AGENDA
PLAN COMMISSION MEETING
RICHFIELD VILLAGE HALL
4128 HUBERTUS ROAD, HUBERTUS, WISCONSIN
August 6, 2020
7:00 P.M.

SUBJECT: Rezoning Petition and Certified Survey Map – Endeavor Business Park 13, LLC.

RE: Pleasant Hill Bar
Site Plan and Erosion Control Review

SHEET 1 OF 4 SHEETS

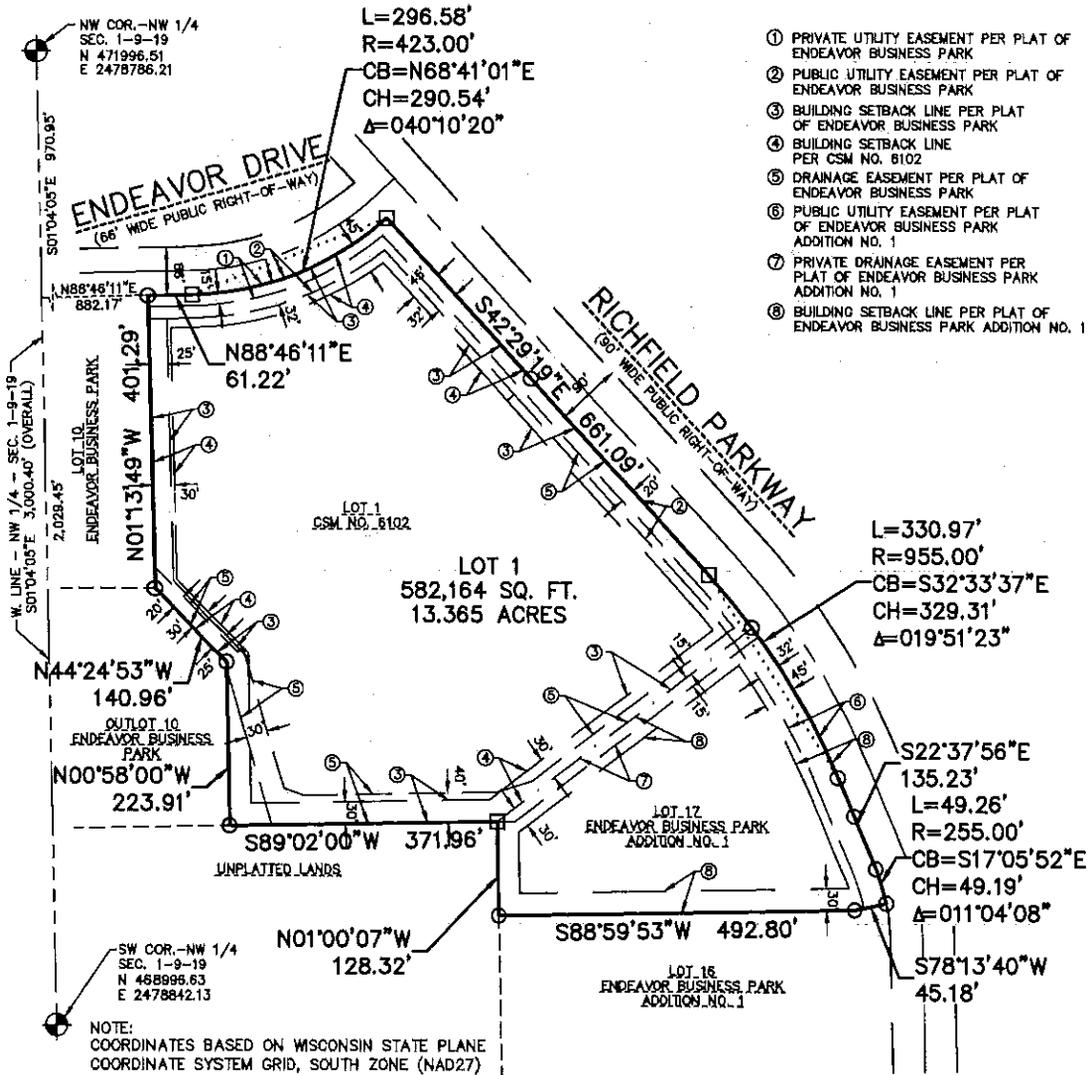
Sheet 1:

- Verify pipe symbology as noted
- Add borings per Village of Richfield code 330-34 A(8)
- Add existing and proposed topography per Village of Richfield code 330-34(B)
- Endeavor Business Park Addition No.1 is zoned industrial(M-4) show only the appropriate setbacks
- It is our understanding that the drainage easement along the common lot line of Lot 1 and Lot 17 is planned to be moved. Would it be reasonable to show/create the easement on this CSM?

PLAN COMMISSION APPROVAL

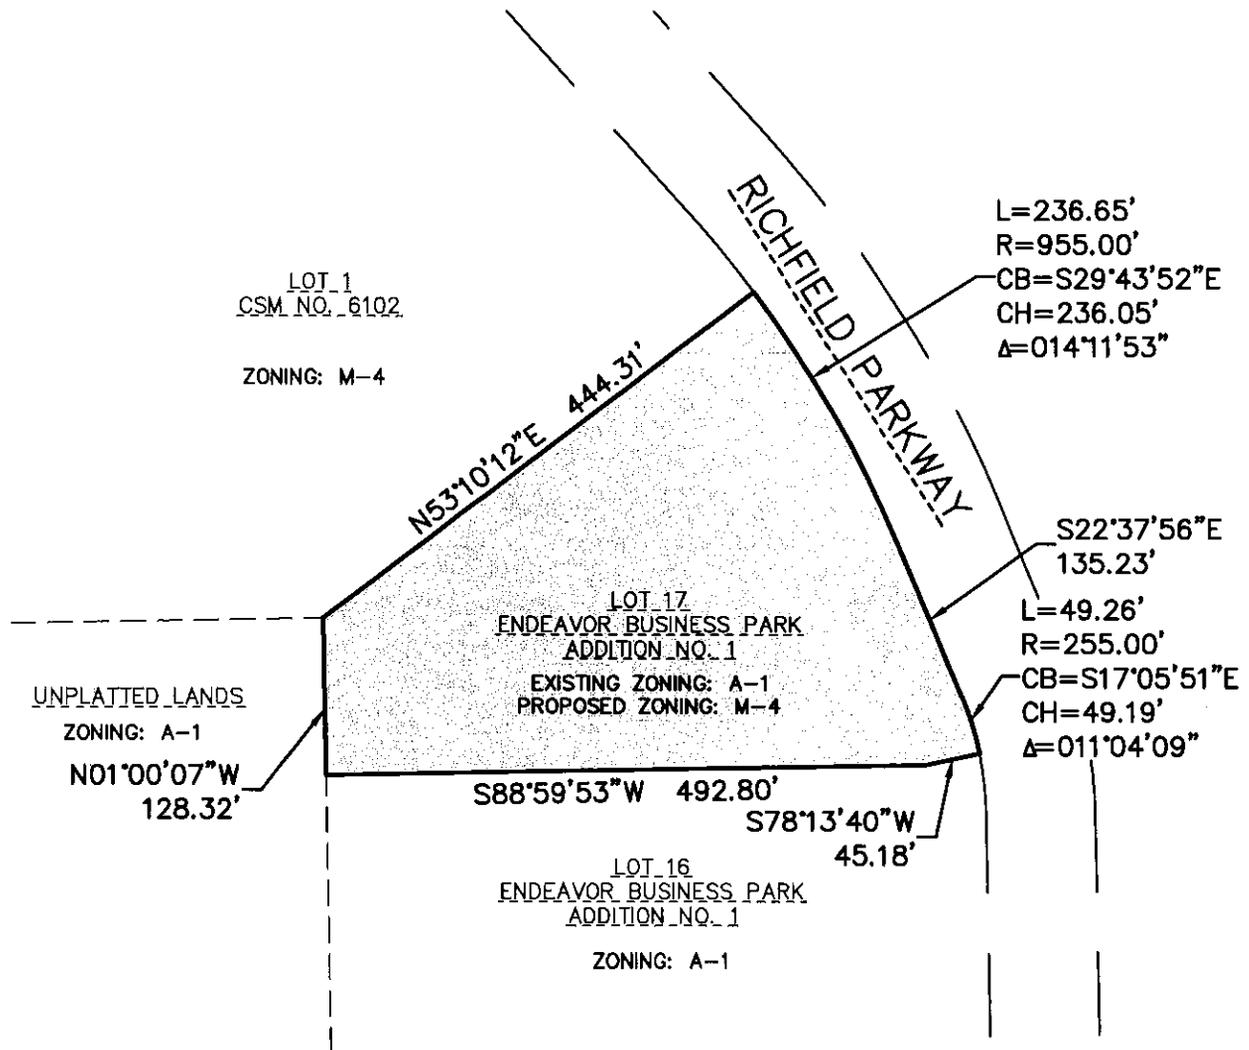
Sheet 4:

- Remove Plan Commission Approval certificate
